SUTHERLAND SHIRE COUNCIL ASSESSMENT REPORT

Panel Reference	2017SSH019
DA Number	DA17/0467
LGA	Sutherland Shire
Proposed Development:	Refurbishment and restoration of Heathcote Hall, construction of 35 townhouses and 20 apartments, associated landscape works and 56 lot strata subdivision
Street Address:	Lot 1 DP 725184, Lot 2 DP 725184 (No. 1-21) Dillwynnia Grove, Heathcote
Applicant/Owner:	Ink Architects Pty Ltd
Date of DA lodgement	28 April 2017
Number of Submissions:	264 groups/individuals to the first notification period and 54 groups/individuals from second notification period.
Recommendation:	Deferred Commencement
Regional Development Criteria (Schedule 7 of the SEPP (State and Regional Development) 2011	Schedule 4A of the Act (in accordance with correct version of the EP&A Act at the time of lodgement)
List of all relevant s4.15 (1)(a) matters	<ul style="list-style-type: none"> • State Environmental Planning Policy 55 – Remediation of Land • State Environmental Planning Policy 65 – Design Quality of Residential Apartment Development • Heritage Act 1977 • Rural Fires Act 1997 • Sutherland Shire Local Environmental Plan 2015 • Sutherland Shire Development Control Plan 2015 (DC

Site layout as originally proposed with the Development Application

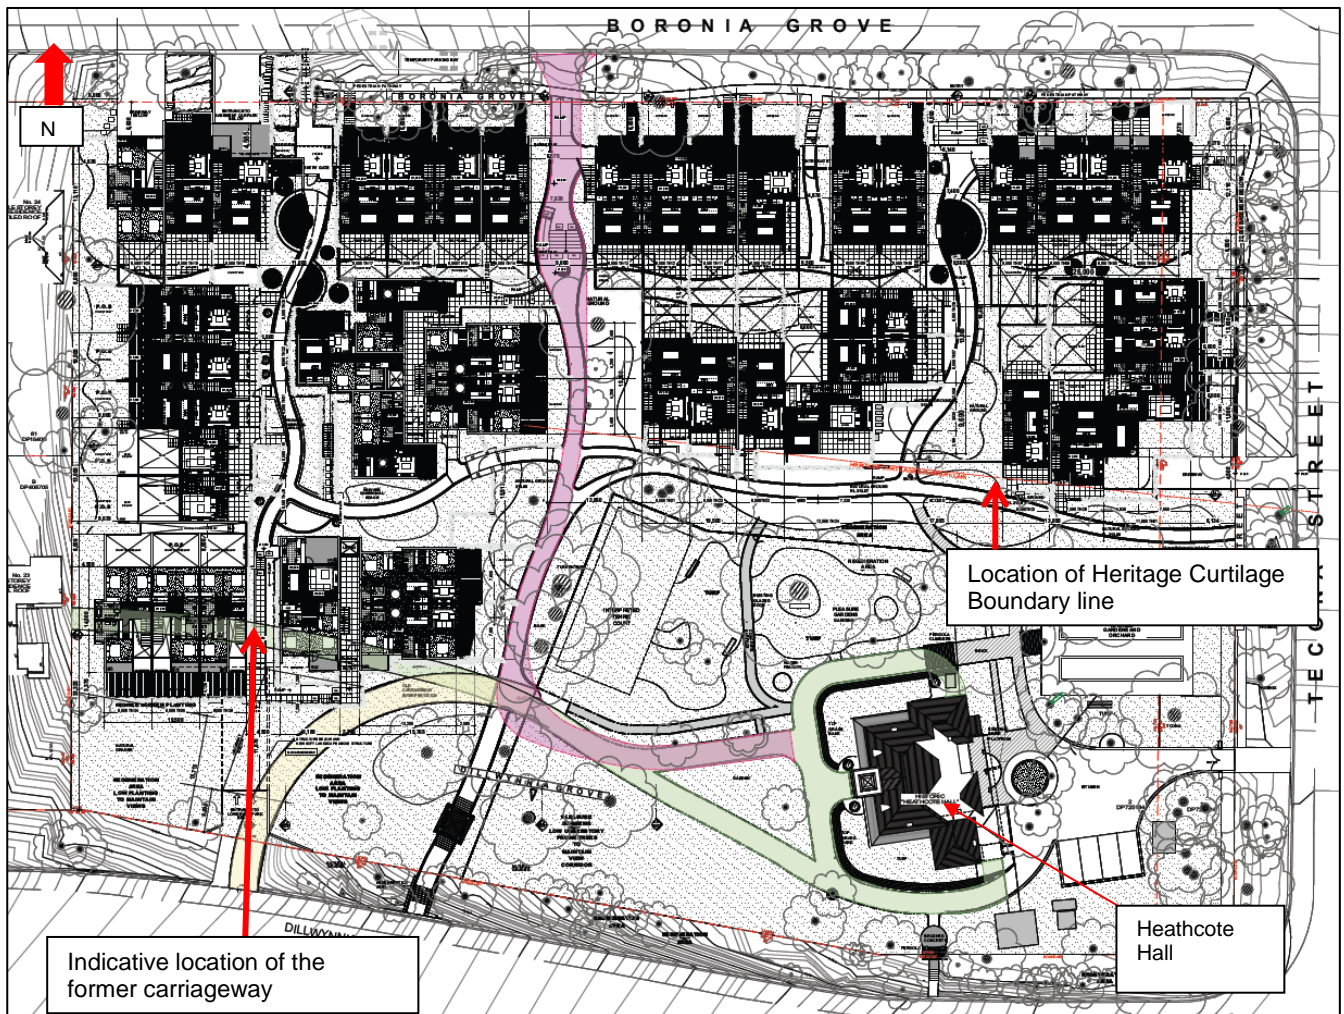
However, there were design modification imposed in these original GTAs, whereby the Heritage Council required amendments to various aspects of the development as they encroached into the setback and curtilage areas as identities in the CMP. Encroachments can be seen below on the original plan submitted with the application. Further the setbacks and curtilage were not clearly identified on the plans.

The original GTAs would require design modification. However, these would not be required until Section 60 stage (post any consent) rather than at development assessment stage. As a result of these general terms there was no certainty for Council regarding the future location of the dwellings and other built form.

Amended site layout as proposed in amended plans identifying the carriageway and Heritage Curtilage

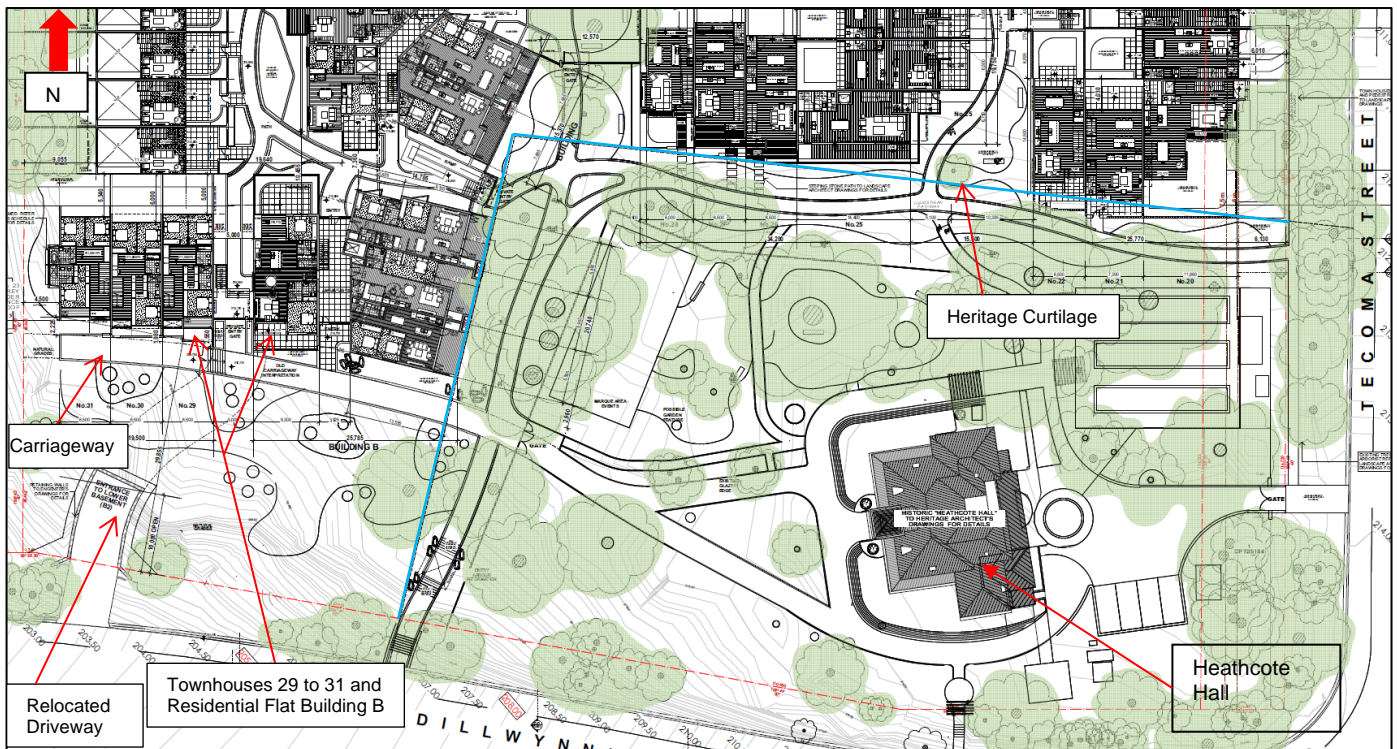
In response the applicant relocated a number of dwellings further north to address the GTAs. In particular Residential Flat Building B and Townhouses 20-31 were repositioned further north, as can be seen on the plan below.

All amended plans and supporting documentation were sent to the Heritage Council for assessment. On 21 May 2018 Council received the updated General Terms of Approval (copy attached at **Appendix K**). The revised General Terms of Approval include a number of conditions requesting additional information to be submitted with the Section 60 application, *“in order to clarify issues and enable a thorough impact assessment”*.

The additional information requested by the Heritage Council includes *“Amended plans overlaid with the development and setback zones identified in the CMP” and “Information to clarify how the private open space of townhouses that encroaches into the reduced landscaped setting/ pleasure garden of Heathcote Hall, as well as the original east-west drive, will be detailed to mitigate any potential adverse heritage impacts”*

Therefore it is a recommendation that the development application be granted a deferred commencement in order to provide certainty that the development satisfies the Heritage Council, and the CMP. A deferred commencement condition has been prepared, and amended plans must be

Western elevation of Residential Flat Buildings A and B (as originally proposed)

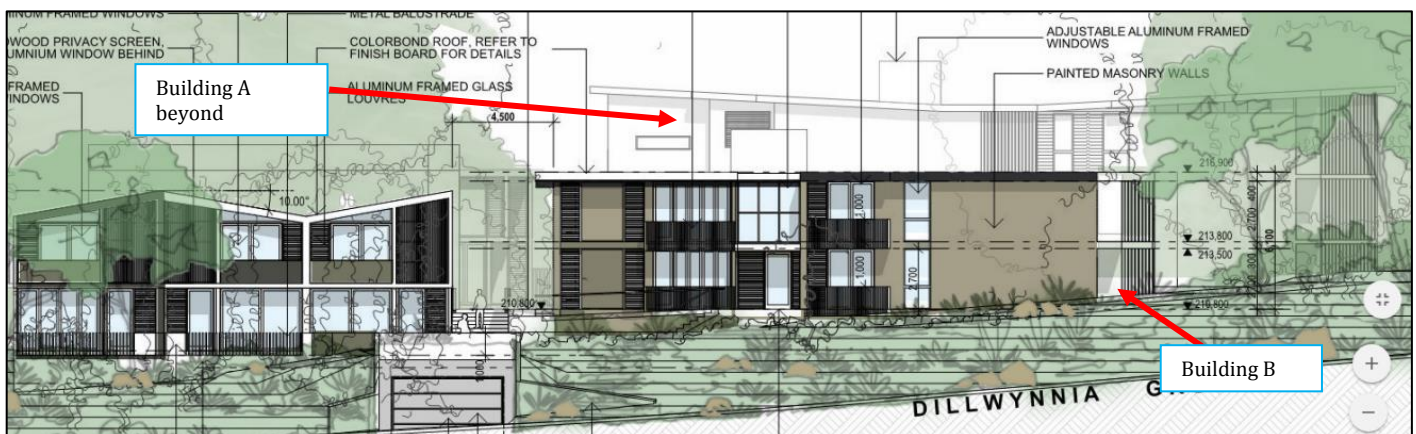
As seen in the figures below the height of Building A as per the original plans and original Clause 4.6 variation request measured 8.8m to the roof at its highest point and 9.8m to the lift overrun. Buildings A and B can be seen below as originally proposed, with Building B below the 8.5m height limit and presented in a form not unlike the town houses in bulk and scale.

Several concerns were expressed in Council's letter to the applicant, the first GTAs issued by the Heritage Council and follow up workshop and meeting. These matters included the non-compliant height of Building A; encroachment of the heritage curtilage contained within the Conservation Management Plan (CMP); and the reduced setbacks along Boronia Grove.

Western Elevation of Residential Flat Building A and B (as amended)

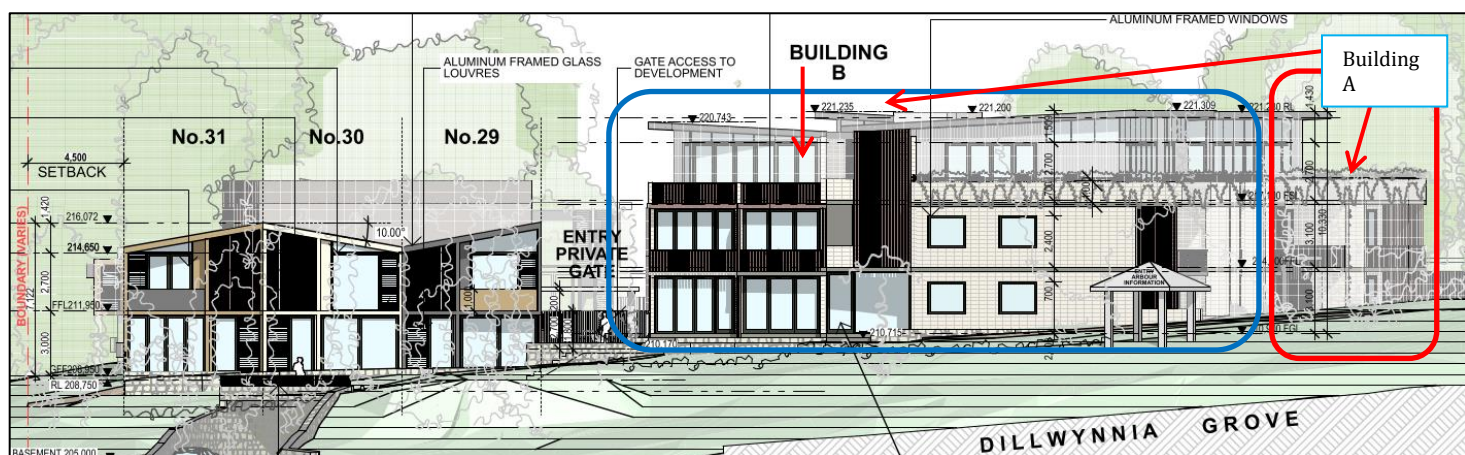
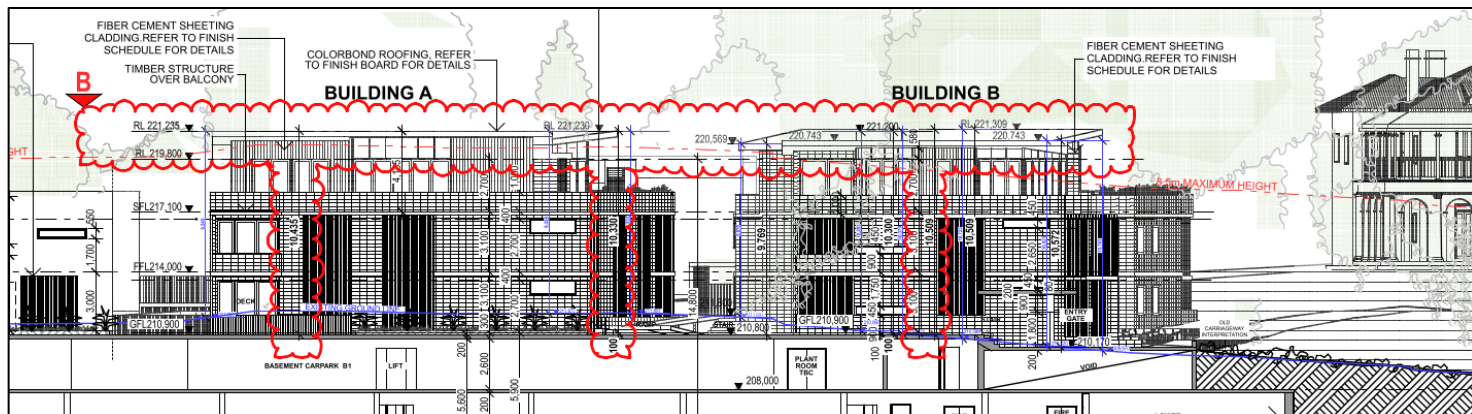
The applicant presented this additional level to Building B, at the workshop and subsequent meeting. Council advised on both occasions that if a third storey to Building B was to be considered, it would need to be well designed, recessive in nature at the third level, and responsive to the context and setting. Council advised that it would assess the built form and response to the context once final plans had been submitted. The amended plans show the apparent flat roof of Building B amended to replicate the butterfly roof form of Building A. Amended elevations have been included below. The revised scheme presents an increased roof height of Building A to 9.545m and Building B to 10.763m. Townhouses 30 and 31 adjacent to Building B are also above the 8.5m height control in the modified plans.

The reduction in height of Building will provide a transition to the residential development to the south and west, and the significant heritage areas to the south and east. There is no justification for townhouse 30 and 31 to be above the height limit and a condition is recommended that these be a maximum of 8.5m in height.

There is a public benefit to maintain the height development standard of Residential Flat Building B and Townhouses 30 and 31 in the circumstances of this case. Building B and Townhouses 30 and 31 will be required to be reduced to have a height no greater than 8.5m. This reduction in height is to provide for a transition in bulk and scale down to the adjacent high significance heritage area (as per the CMP), to the Heathcote Hall and to the adjacent low density dwellings to the south, across Dillwynia Grove. (See annotated plan in **Appendix L**).
